INTRODUCTION

OUTLINE OF NEW FEATURES

The following changes have been made to the new FJ Cruiser.

4. Tire and Disc Wheel

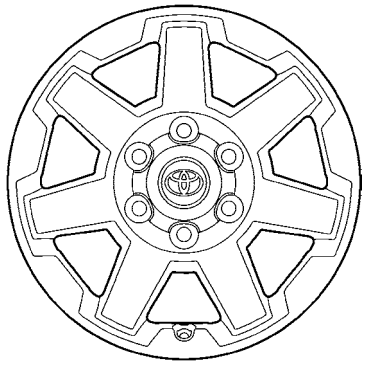
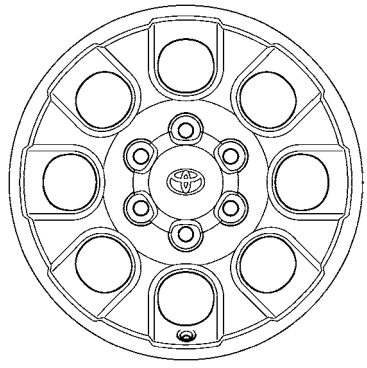
The 17 inch aluminum wheel design has been changed.

Models		New	Previous
Tire Size		265/70R17	←
Wheel	Size	17 × 7 1/2J	←
	Material	Aluminum	←
P. C. D.*	mm (in.)	139.7 (5.5)	←
Inset	mm (in.)	15 (0.6)	←
Design		 07D8CH01D	 07DIN401S
